DART SERVICE INSTRUCTION

TO AMEND IIN-D412-704 REV. C OR EARLIER
AND ICA-D412-704 REV. 4 OR EARLIER
REF CANADIAN STC SH93-34
REF FAA STC SR00957NY
REF EASA STC EASA.IM.R.00696

PURPOSE

Figure 5 - Detail L or Figure 25-4 - Detail L

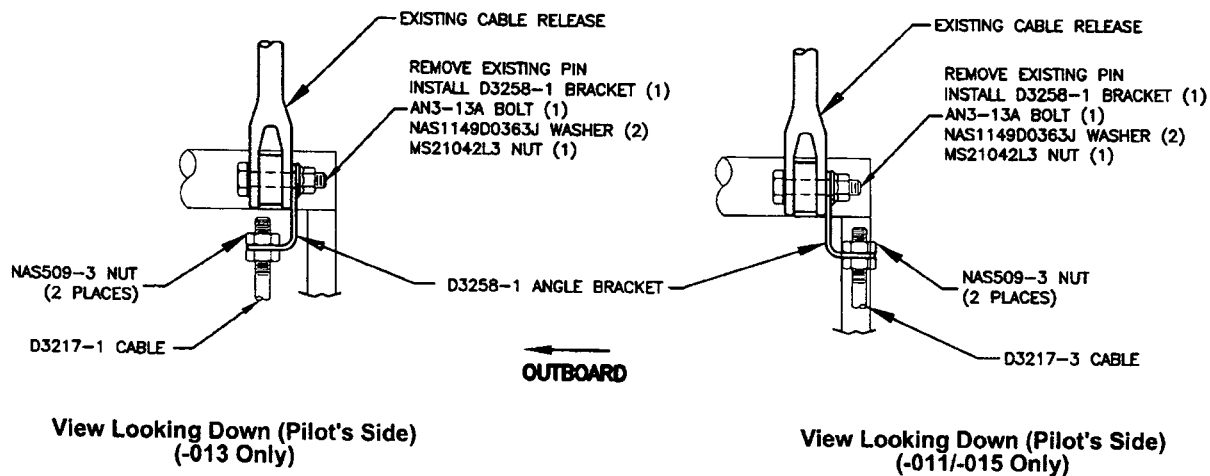
The purpose of this Dart Service Instruction is to correct part number error in Installations Instruction IIN-D412-704 Rev. C or earlier and Instructions for Continued Airworthiness ICA-D412-704 Rev. 4 or earlier. The AN3-13A bolt should be replaced with an AN3-10A bolt in Figure 5 - Detail L in IIN-D412-704 and Figure 25-4 Detail L in ICA-D412-704. See sheet 2.

Revise Detail L Figure 5 of IIN-D412-704 and Detail L Figure 25-4 of ICA-D412-704 as follows:

NOW

WAS
